UNITED STATES PATENT AND TRADEMARK OFFICE

APPLICATION NO.	FILING DATE	FIRST NAMED INVENTOR	ATTORNEY DOCKET NO.	CONFIRMATION NO.
09/773,944	02/01/2001	Robert K. Jenner	1019-US	9154

Office Action Summary

DETAILED ACTION

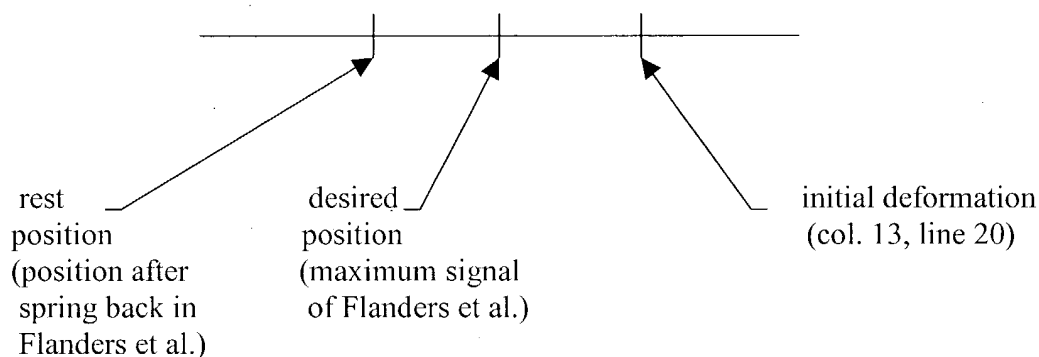
6. Applicant argues that Flanders et al. do not teach "finding a desired position of an optical axis of the optical component relative to a rest position of the optical axis of the optical component". However, in col. 13, lines 14-15 and 19-20, applicant teaches that the "desired position" is the position where maximum signal is detected. The "rest position" described in col. 13, lines 21-24 is the position after "snap back". The "rest position" may not end up at the position associated with maximum coupling as described in col. 13, lines 29-33.

Flanders et al. specifically teach in col. 13, lines 14-15: "Simultaneously, the **magnitude of the signal transmitted by the fiber is monitored until a maximum signal is detected** in step 666 of Fig. 20.". The monitored maximum signal corresponds to the claimed "finding a desired position of an optical axis of the optical component" because the maximum signal is the desired position. In col. 13, lines 29-33, Flanders et al. specifically teach: "If it is subsequently determined in step 670 that the optical component, i.e., the fiber **is not at the position associated with the maximum coupling**, the deformation step 668 is performed again until the position is within an acceptable tolerance.". Therefore, after releasing and when snap-back occurs (col. 13, lines 22-24), the optical component may not be at the desired maximum signal or "desired position". Note that in col. 13, lines 24-28, Flanders et al. teach that "plastic

deformation” is induced during the step of finding the desired position as claimed. The position after snap back is considered the “rest position”. See illustration below:
